# ECR/Documents for Information and Approval

Giulia Romagnoli and Natalya Kahn for BE-EA, 2025-01-21

SPSX-SF-EC-0016

## AUG installation EHN2+ AUL removal EHN1, GIF++/H8 and EHN2/M2/BA82

Figure 1: AUL removal in PPE134, PPE138 and PPE146 in EHN1 [2].

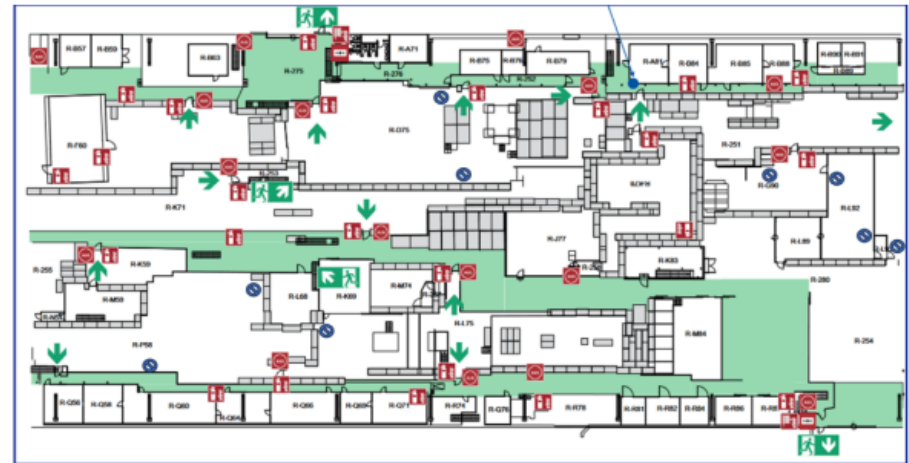
PPE134 (R-K47+R-K39): 5x AUL à supprimer  
PPE138 (R-P40): 2x AUL à supprimer  
PPE146 (R-K52): 1x AUL à supprimer

Figure 3: AUL removal and AUG installation in EHN2 (ground floor) [3].

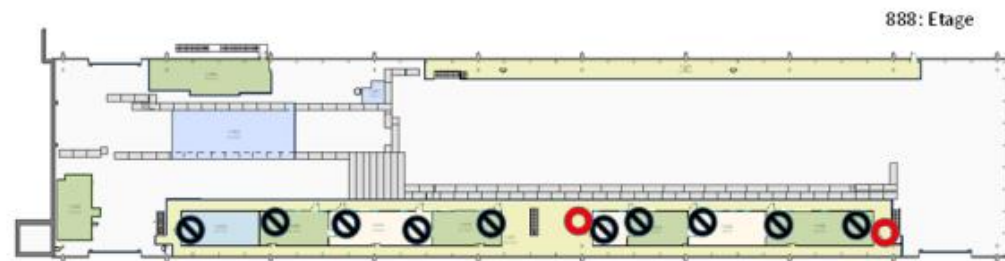
One AUL will remain in operation in EHN2 zone R-0009, however the NANO PLC system will be removed entirely. How will this impact the functioning of the remaining AUL ?

Accepted with Warning by **VEIT Benjamin Moritz** (EP-UFT) Created on 2024-12-17, 16:09  
In 3.2 install 10 additional AUG buttons is mentioned. Looking at the figure 3+4 I see 10 red rings for new AUGs. Some of the e.g. next to the entry of PPE221 are already existing. Please review the position of the newly added AUGs if they do not yet exists. If some additional could be added in PPE221 at the height of SM2 this would be good.

Concerning the EIS system no details are required.  
With reference to Yacine's comment the remaining AUL will be directly wired to corresponding breaker or we will provide AUL interface in case it has to actuate more than one breaker.

Asset Replacement Request – Replacement/Installation Tables  
XTDV.041.528, XTDV.042.500, XTDV.021.612

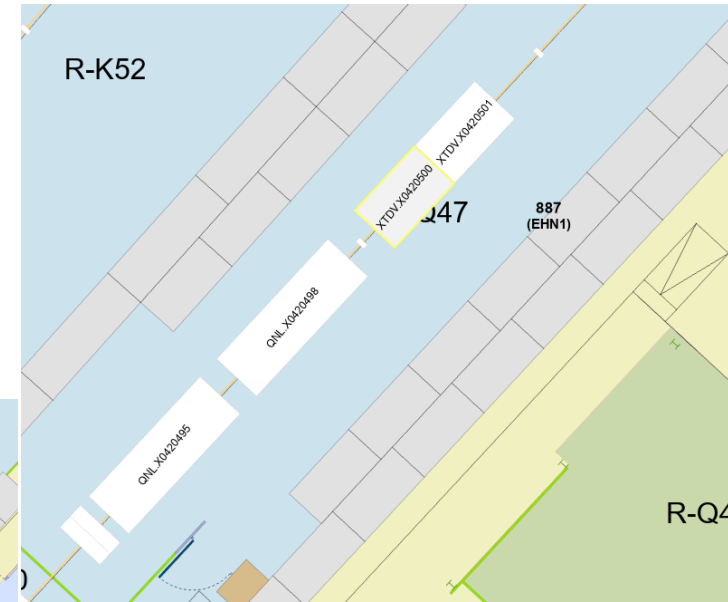
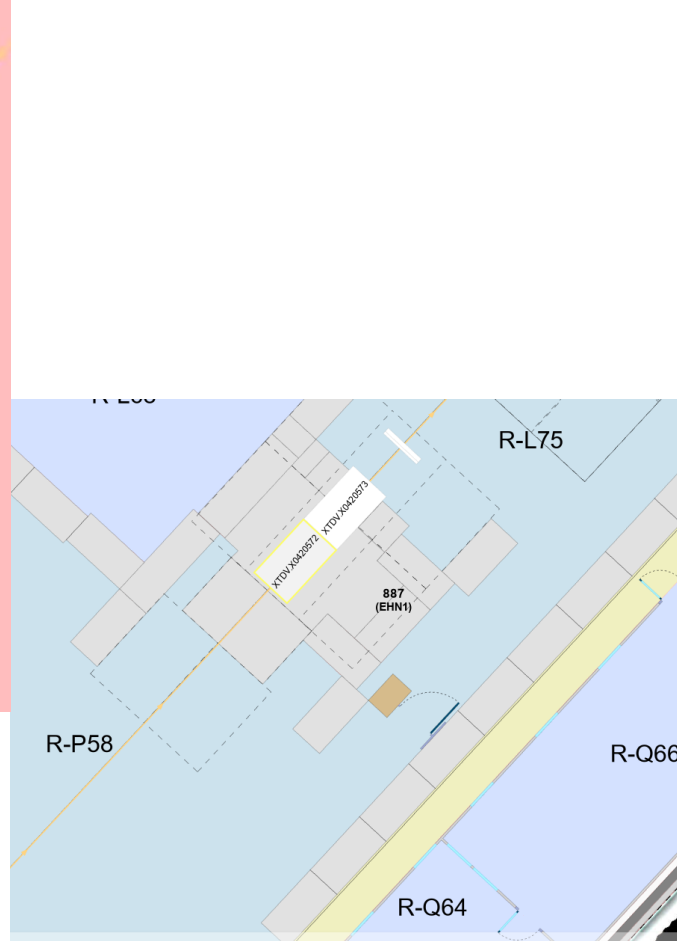
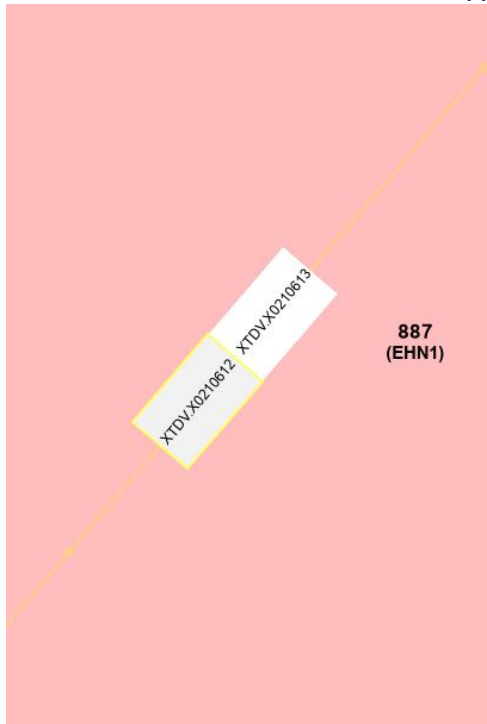
4 de ces XTDVs doivent être modifiées avant installation (en janvier). Modification à suivre si il y a des complications et impossibilité d'installation pendant ce YETS.

Quelle est l'activation de ces pieces?  
echange à l'identique?

OK to proceed with the proposed replacement of the 6 consolidated XTDVs.
